Errata

Applies to IP65 step motors from pilot production build

Motors with orange, orange/white, red, red/white, black, black/white, yellow, yellow/white.

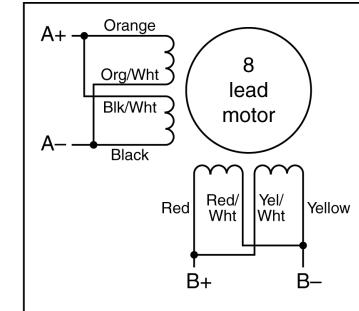
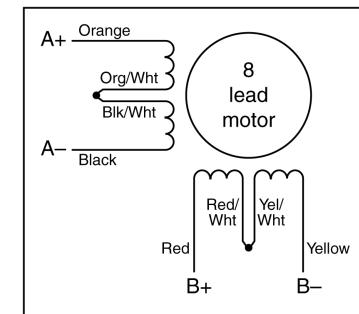
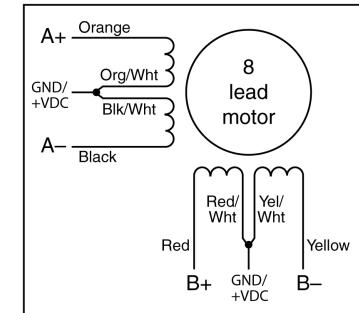
1. Some units have cables that are rated 80°C. These motors should be operated such that the case temperature does not exceed 80°C.
2. The wire colors may differ from our standard. See wiring diagrams below and on the back.

Eight lead motor connected in PARALLEL to a bipolar drive.

Eight lead motor connected in SERIES to a bipolar drive.

Eight lead motor connected to a unipolar drive.
